FREDERICK COUNTY PLANNING COMMISSION

TITLE: Kiddie Academy

FILE NUMBER: SP-94-21, AP 16943 (APFO 16944,
FRO 16945, SWM 17080)

REQUEST: Site Development Plan Approval

Exhibit #1 Kiddie Academy Site Plan Rendering

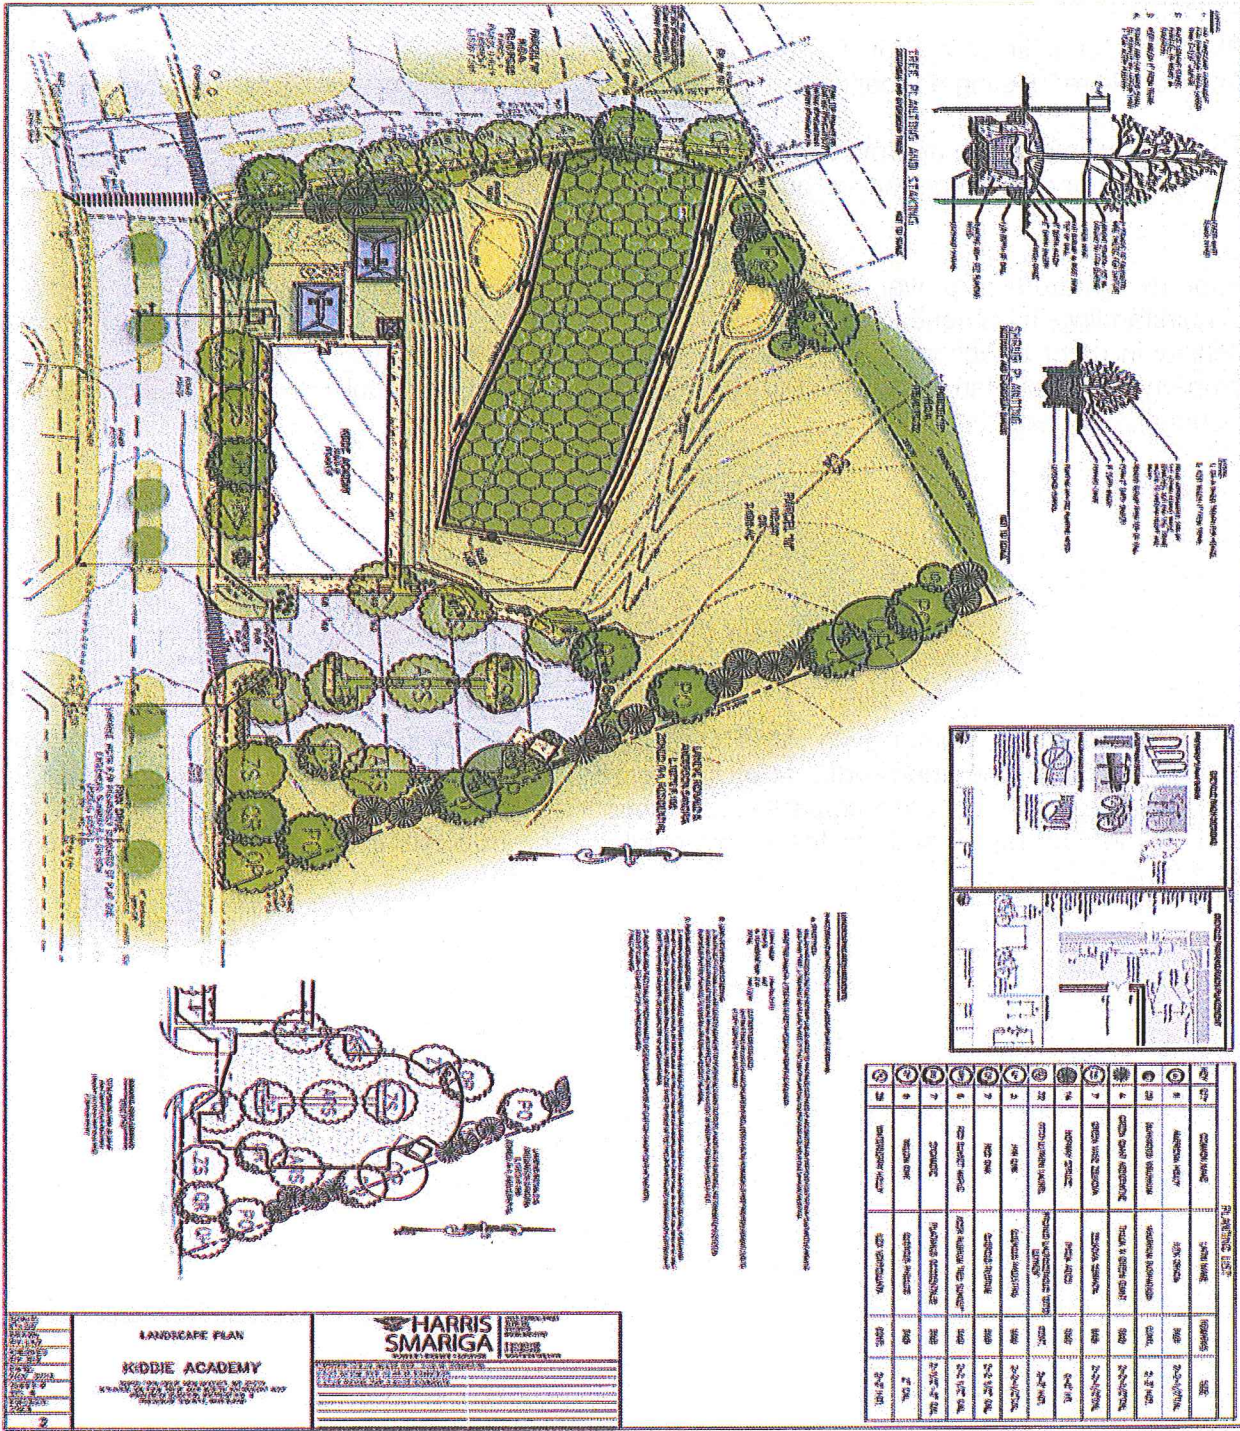
3. Landscaping §1-19-6.400: The Applicant has provided a landscaping plan on Sheet 2 of the site plan. The Zoning Ordinance requires a total of 22 street trees adjacent to the existing public rights-of-way along Finn Drive and North Steamboat Way. The Applicant is requesting a modification to allow 16 trees along these roadways due to conflicts with utility lines and sight distance/visibility concerns at the Finn Drive entrance. The site plan includes 7 trees and understory shrubs in the parking lot, providing the 20% canopy coverage and meeting the requirements listed in §1-19-6.400 of the Zoning Ordinance. It appears that there are several opportunities to locate the 6 additional required street trees on-site, but not adjacent to the right-of-way. Staff supports providing the 6 required street trees at an alternate location on-site rather than eliminating the requirement.

4. Screening §1-19-6.400: The plan proposes a mixture of evergreen and deciduous species, reaching heights of 6 ft. to 15 ft. at maturity, to act as screening and buffering for the residentially-zoned parcel to the east and a portion of the adjacent townhomes to the north. The entire northern property line that abuts the full length of townhomes must be screened and buffered.

Note 8 of the site plan indicates 10 building mounted lights, but the Architectural Plans on page 3 depict 16 building mounted light fixtures. The Applicant shall revise the plan to indicate the correct number of building mounted lights that will be installed.

3. The Applicant shall add dimensional measurements to the building mounted sign as shown on the Exterior Elevation Sheet and add dimensional measurements to the proposed free-standing sign on the front of the site.

5. The Applicant shall place additional landscaping along the northern property line to show complete buffering and screening of the adjacent townhomes.

1. Address all agency comments as the plan proceeds through to completion.
2. Prior to signature approval of the site development plan, Note No. 8 shall be revised to include the following text: "Lighting shall be designed and installed to be fully shielded. Lighting shall be directed downward to prevent glare and light trespass onto adjacent properties." Note No. 8 and the Exterior Elevation Sheet shall be revised to reflect the correct number of building mounted light fixtures.

3. Planning Commission approval of the Landscaping Modification (1-19-6.400). The Applicant is requesting a modification to reduce the number of required street trees from 22 to 16; however, Staff supports providing the 6 remaining required street trees at an alternative location on site rather than reducing the requirement.

4. Prior to signature approval of the site development plan, the Applicant shall add dimensional measurements to the building mounted sign as shown on the Exterior Elevation Sheet and add dimensional measurements to the proposed free-standing sign depicted on sheet 1 of the site development plan.

5. Prior to signature approval of the site development plan, the Applicant shall place additional landscaping along the northern property line to show complete buffering and screening of the adjacent townhomes.
